OBJECTION

on grounds of landscape impact

To develop two sand schools with
parking, and change of use of land
from agricultural to equestrian

CDC Ref 13/01128

Fig 10 showing Applicants' Visual Envelope Plan, overmarked in faded blue with enlarged Visual Envelope for the Top and 28-Day Fields. The pink area indicates an estimated VE for the Stourwell Barn Anaerobic Digester (labelled AD site).

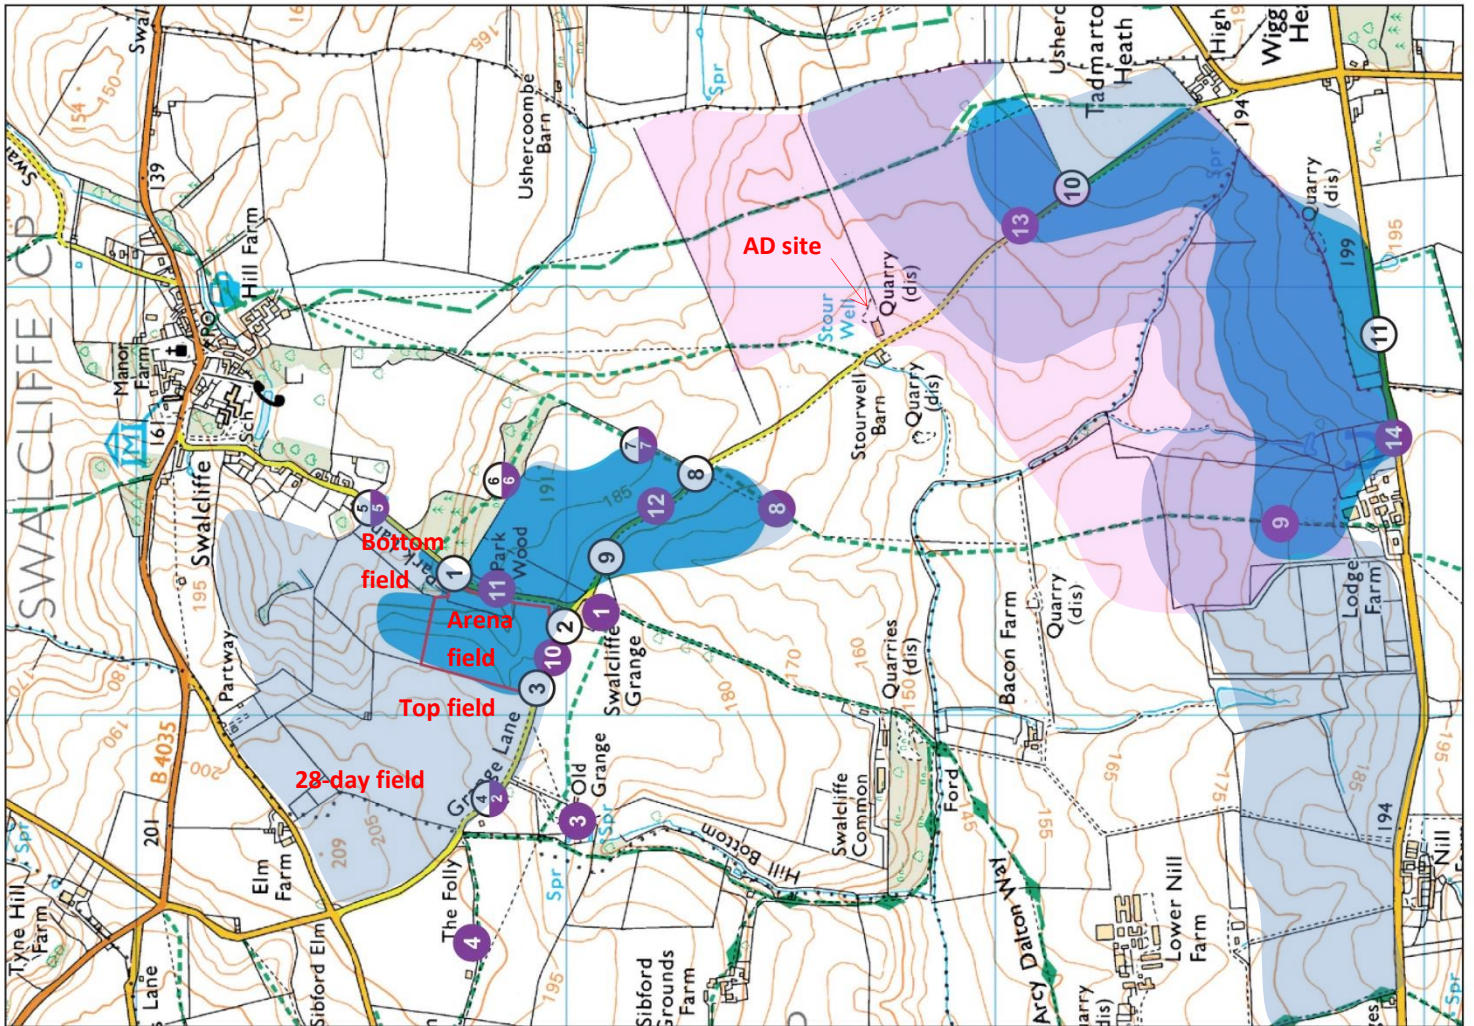
- 4.3. The extent of intervisibility with the surrounding landscape of the Arena Field illustrated on the Applicants' LVIA Plan 4 is not disputed. However it only deals with the Arena Field and does not take account of the whole Application Site. **Fig. 10** takes Plan 4 and modifies the Visual Envelope (VE) to include an estimate of land area with views of the larger Application Site.
- 4.4. This only claims to be an estimated VE area, and has therefore erred on the cautious side. What cannot be in doubt though is the substantial increase in VE, and the additional potential public vantage points from which views of the 28-Day and Top Fields are visible.

- 4.16. Many of these views are from the same paths and roads from which the Swalcliffe Park Equestrian site is also visible, in fact as indicated on **Fig 10** the two developments would be visible together across quite a wide area of shared Visual Envelope.
